{All change order of Plans dated 2/29/80 were prepared by Hwy-DB}

{3}-Denotes changes to C.O. ADD 232 - 2/29/80

C.O. ADD. 232

STATE OF HAWAII
DEPARTMENT OF TRANSPORTATION
HIGHWAYS DIVISION
H-1 VIADUCT (E.B. & W.B.), RAMP A, RAMP F & RAMP G
LONGITUDINAL SECTION
SH. 2 OF 2
KEEHI INTERCHANGE
F.A.I. PROJ. NO. I-HI-1 (131):17
SCALE: AS SHOWN DATE: AUG. 31, '77
SHEET NO. S-5 OF 5-94 SHEETS

PIER H0 COLUMN REINFORCING DETAIL

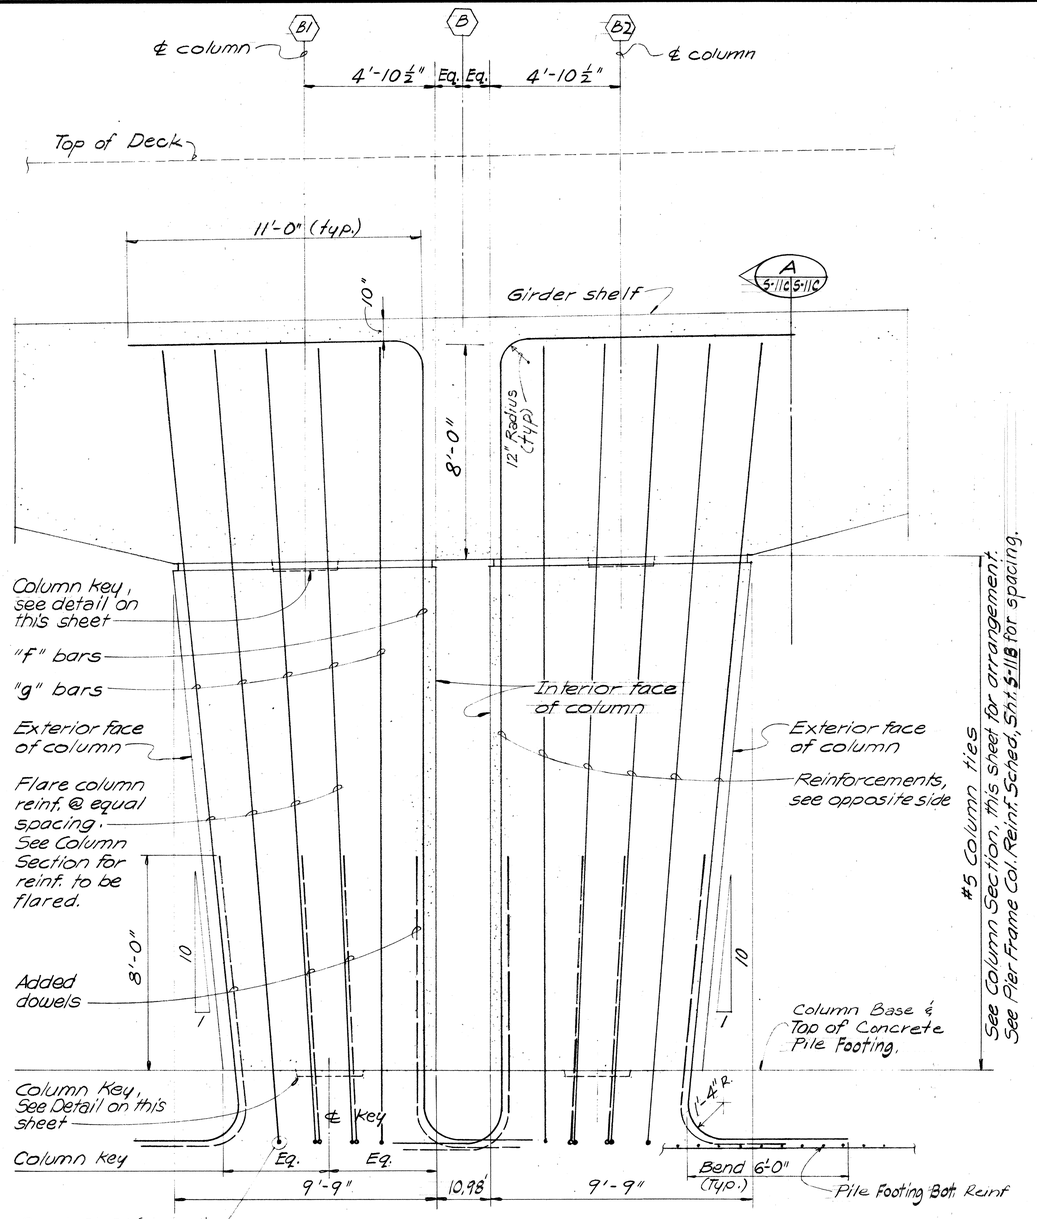
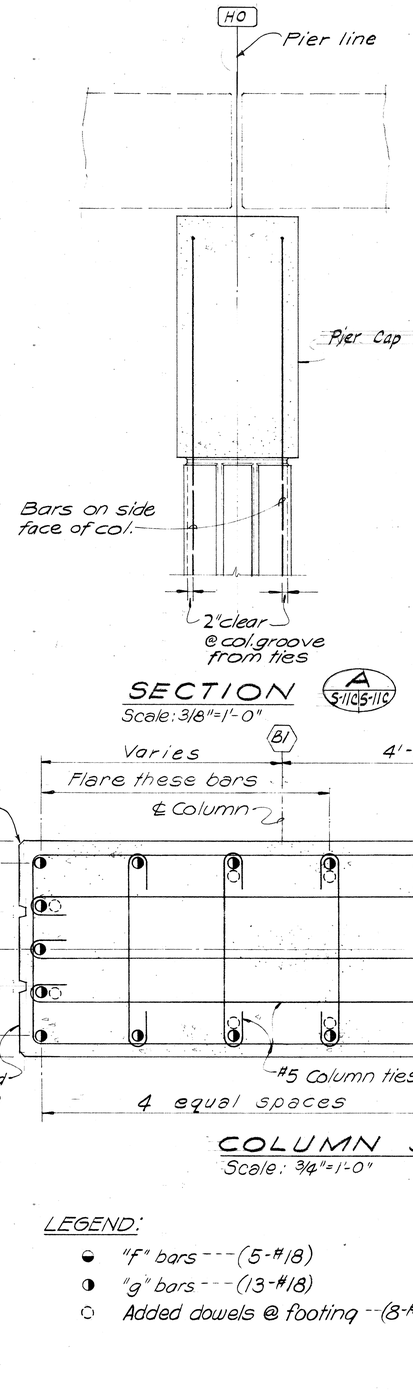
DATE	REVISION
2/29/80	Sheet added to contract plan set for Pier H0 only.

PIER (HO) CAP REINFORCING

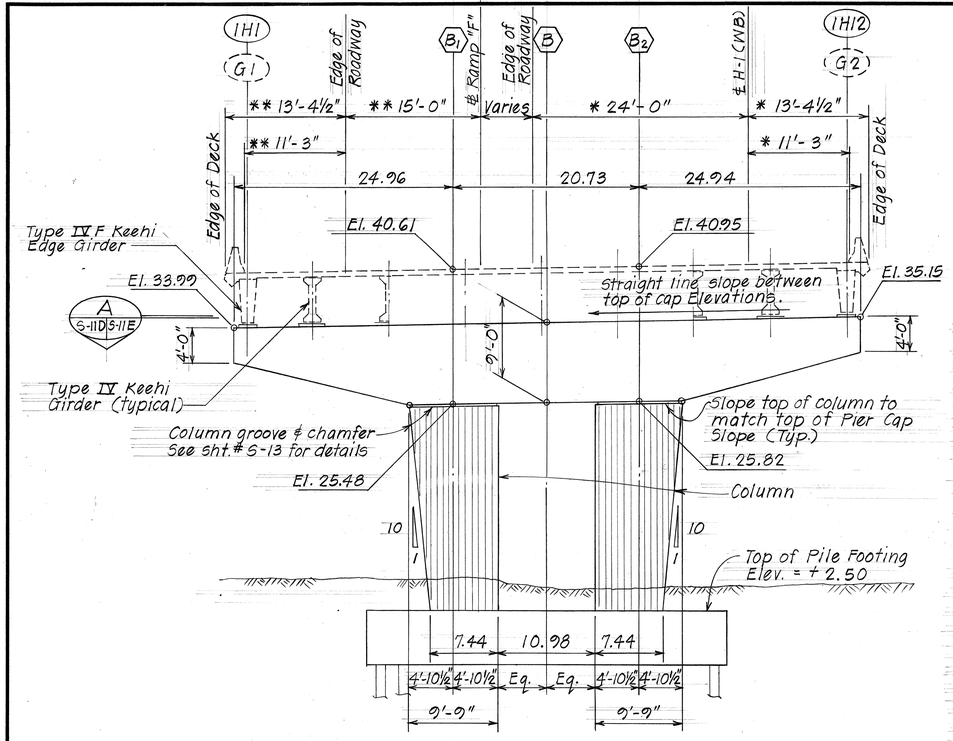
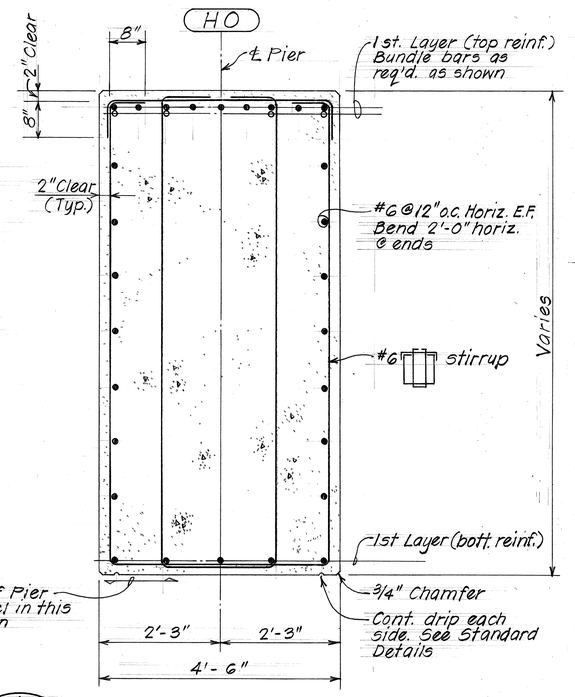
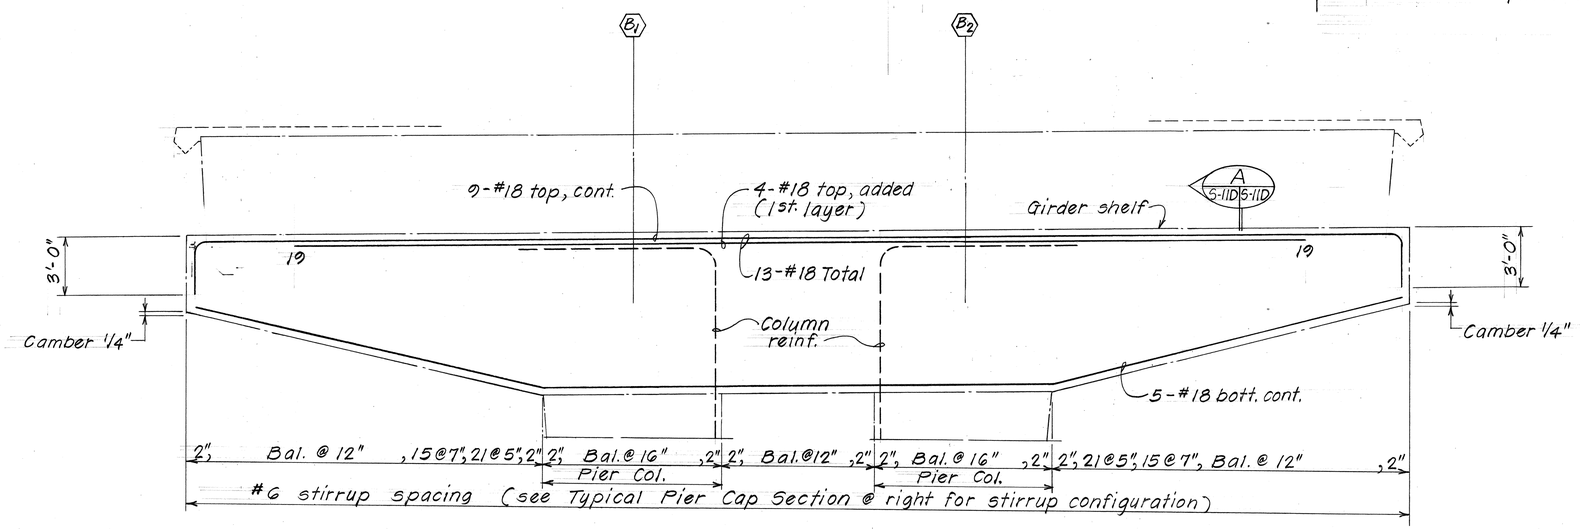
DATE	REVISIONS
2/20/80	Sheet added to contract plan set for Pier (HO) only.

H-1 VIADUCT (EB & WB) RAMP A, RAMP F & RAMP G
PIER H0
PIER CAP PLAN & SCHEDULE
KEEHI INTERCHANGE
F.A.I. PROJ. NO. I-HI-1 (131):17

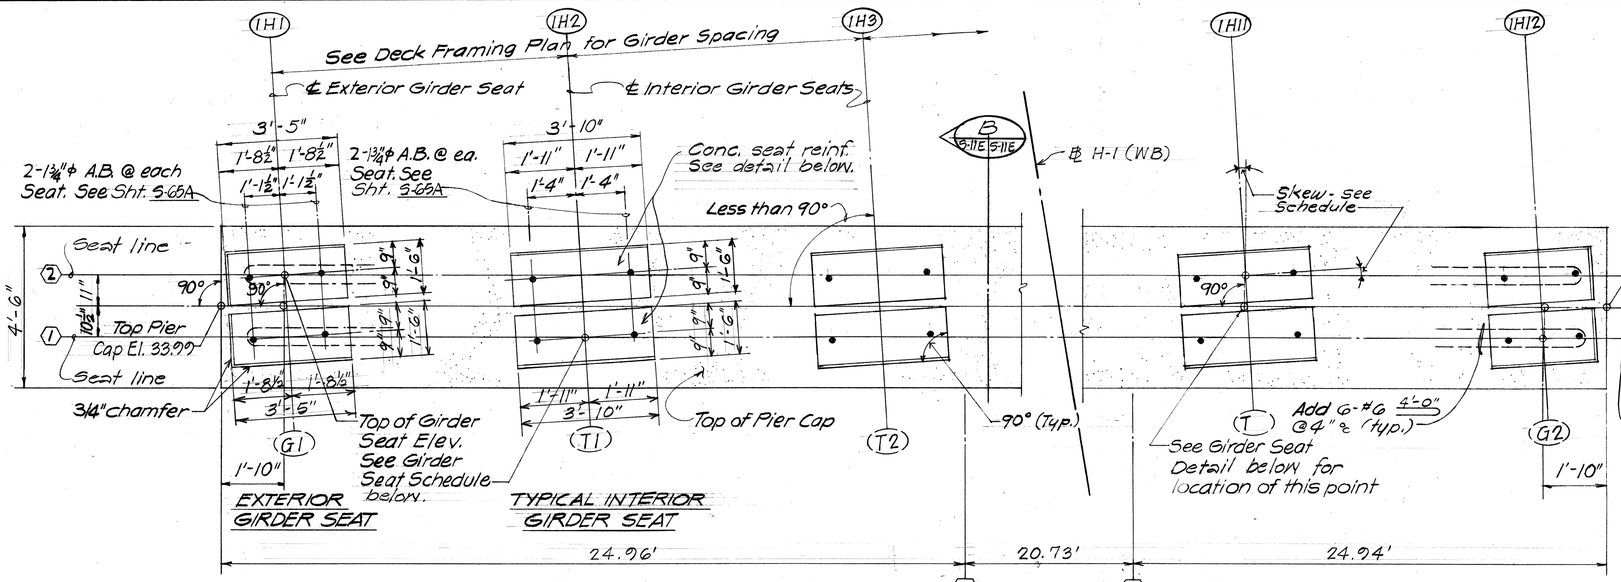
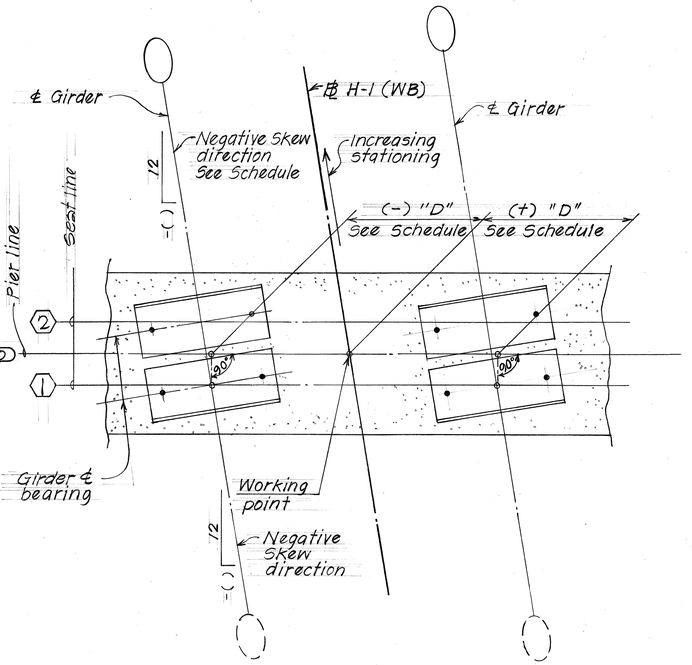
Date	REVISION
2/29/80	Sheet added to contract plan set for Pier H0 only.

PLAN PIER F2
Scale: 3/8" = 1'-0"

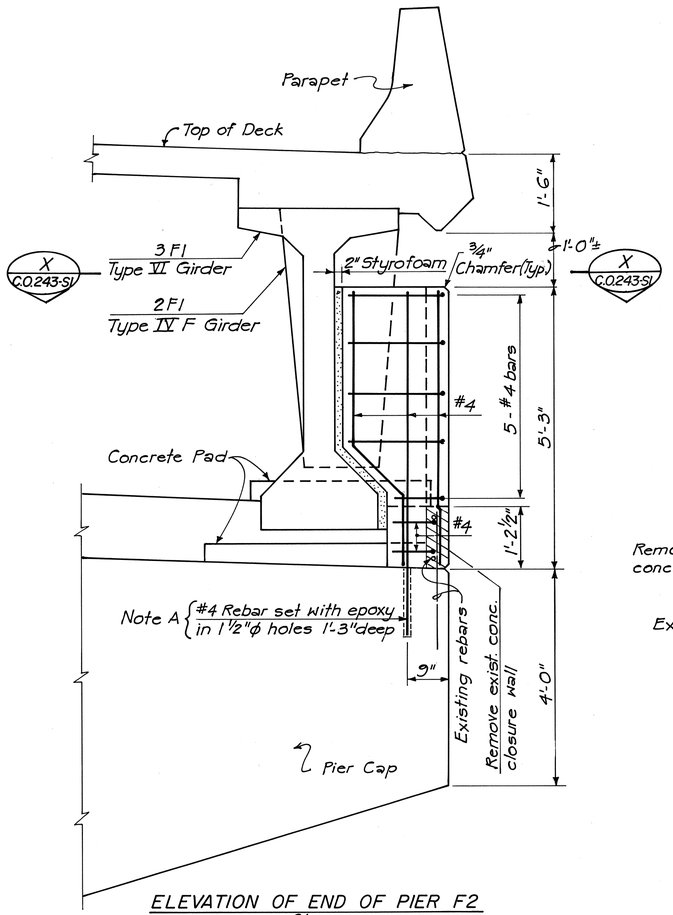
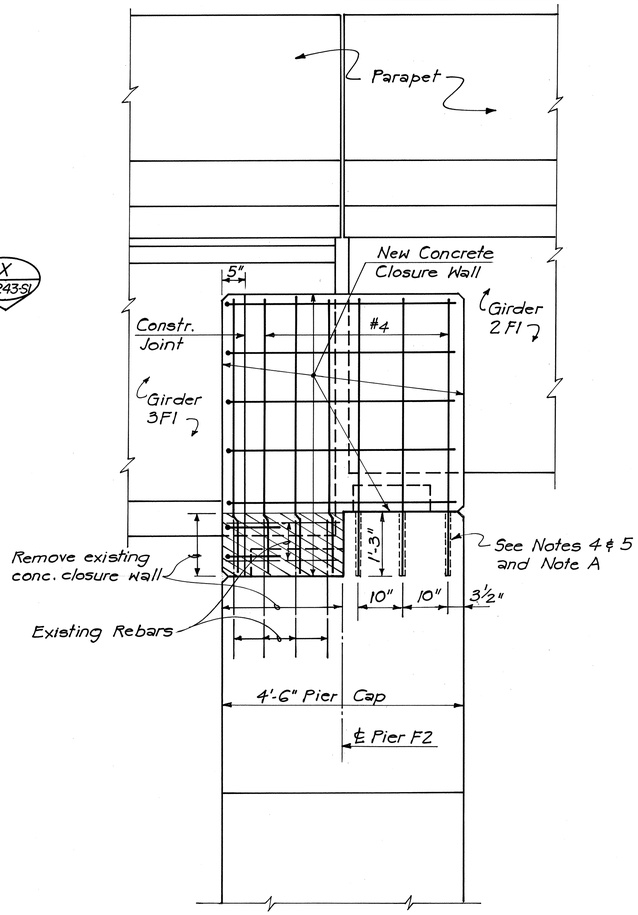
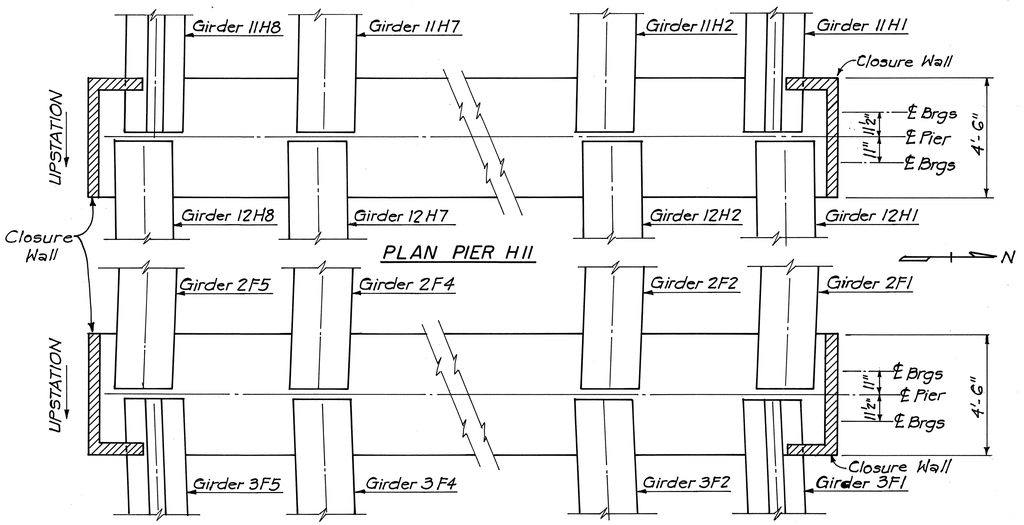
DATE	REVISION
6-19-81	New sheet added for Concrete Closure Walls.

PAYMENT LIMITS
(Piers H3 thru H5, F1 & F2)
N.T.S.

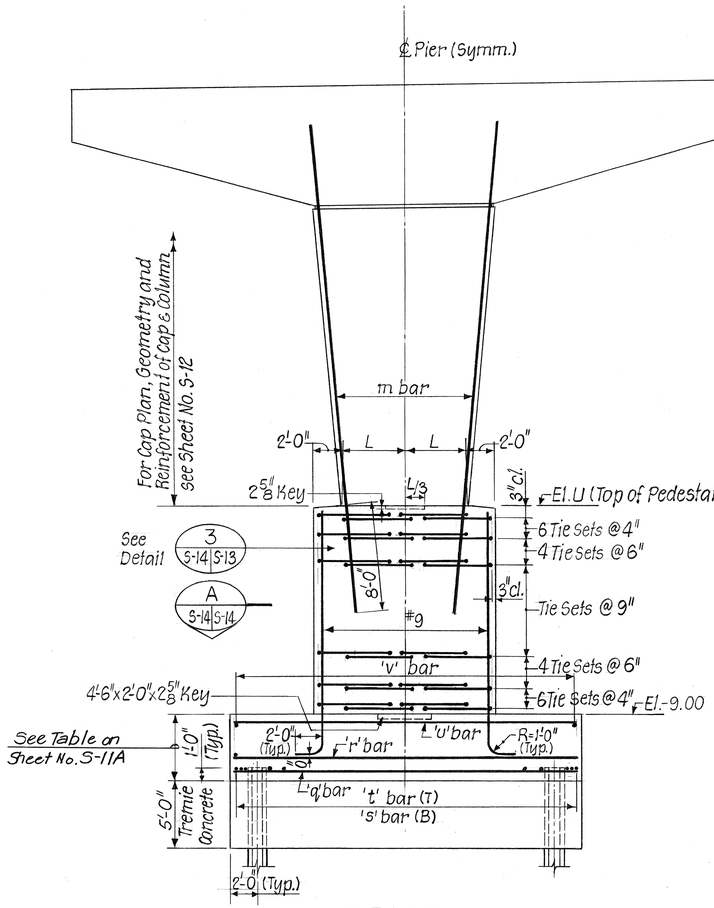
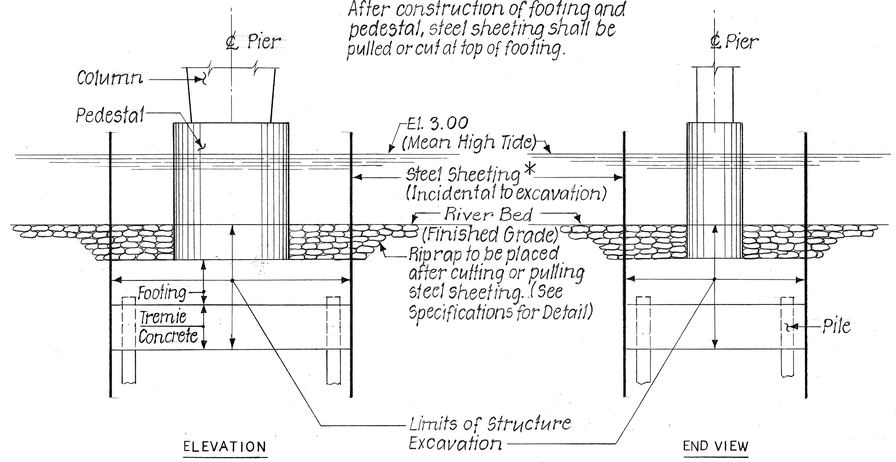
DATE	REVISIONS
7/21/78	Revised Note No.2 Revised footing size and footing reinforcements in Elevation.

TYPICAL BOX SECTION (at face of column)
N. T. S.

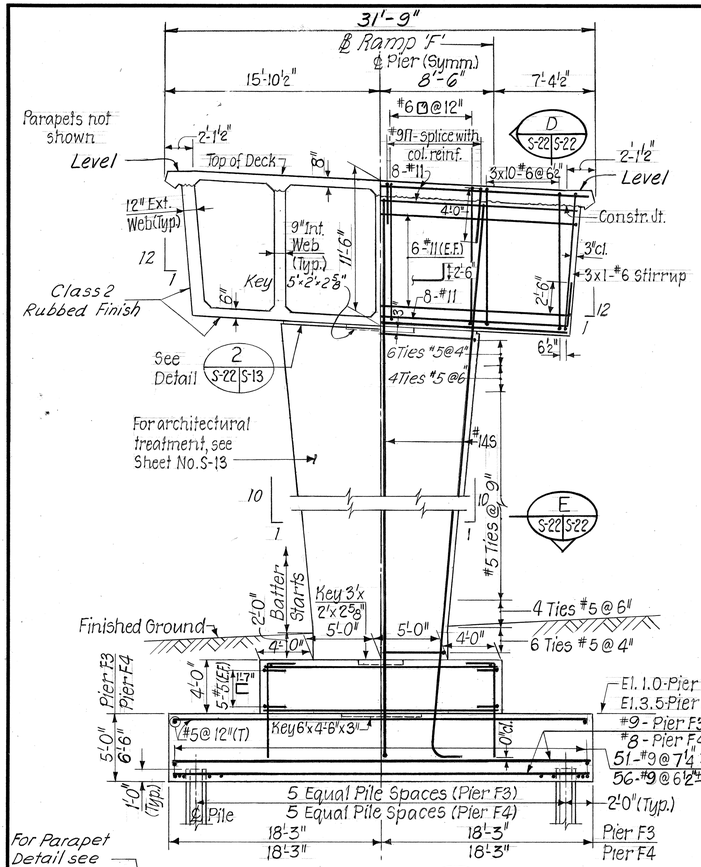
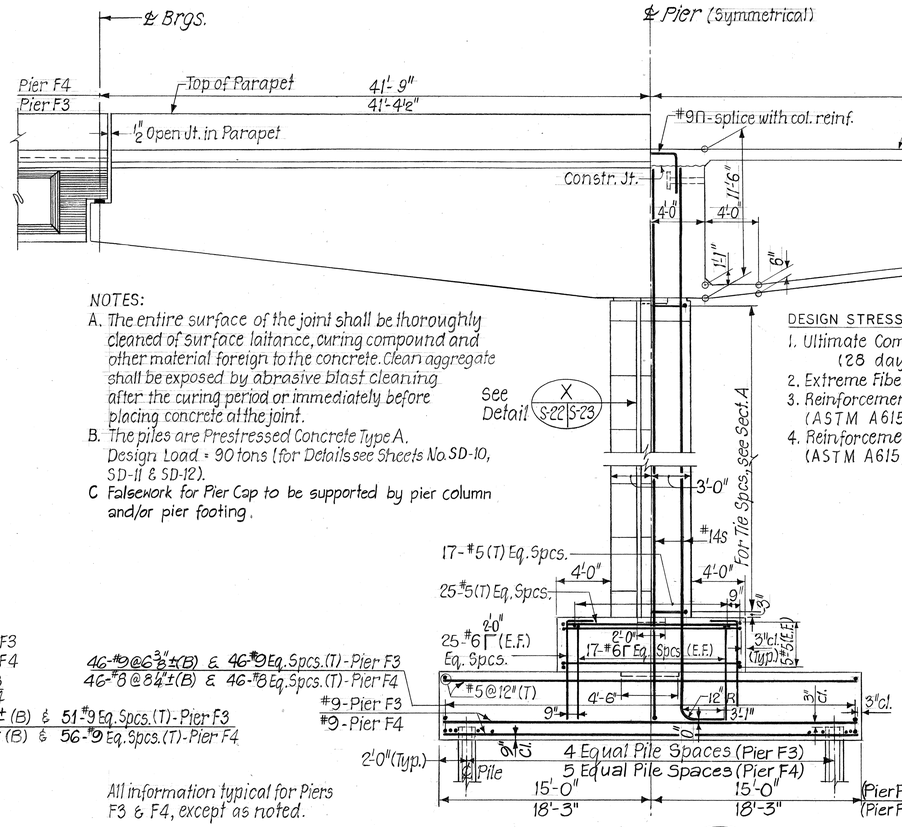
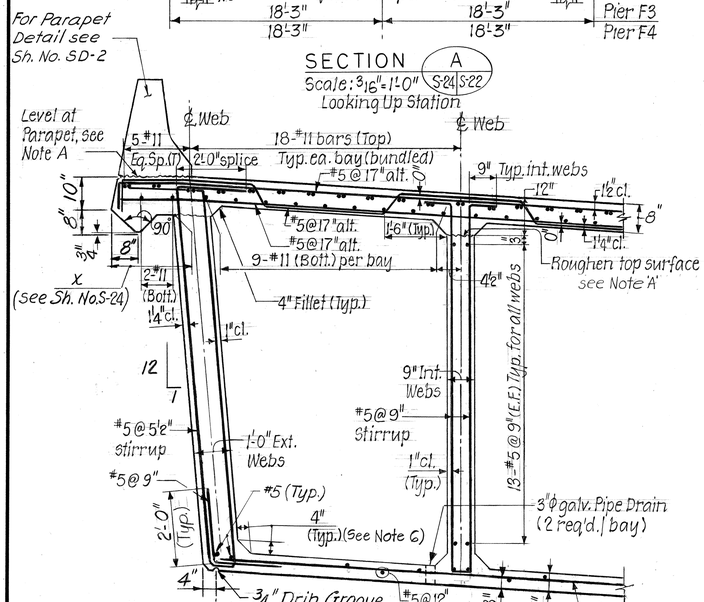
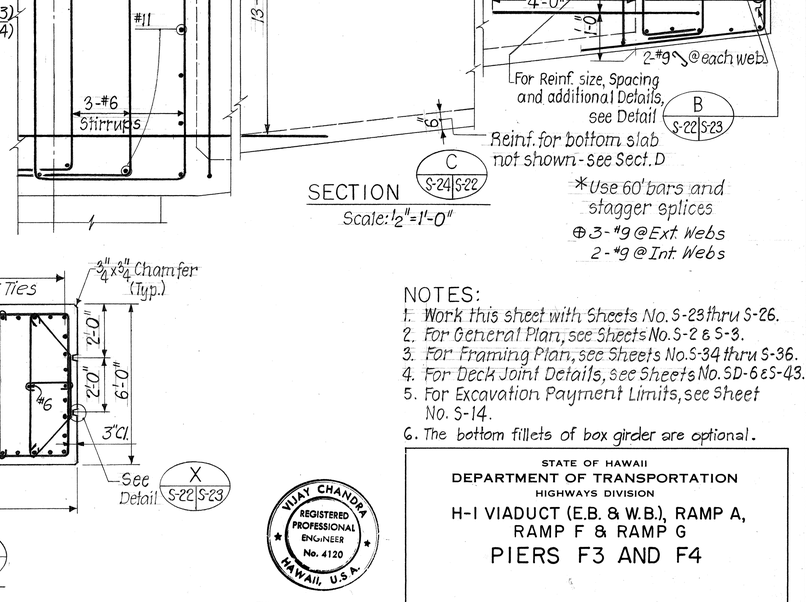
DATE	REVISIONS
7/21/78	Revised ftg. size & ftg. reinforcements in Sections A S-24 S-22 & B S-24 S-22
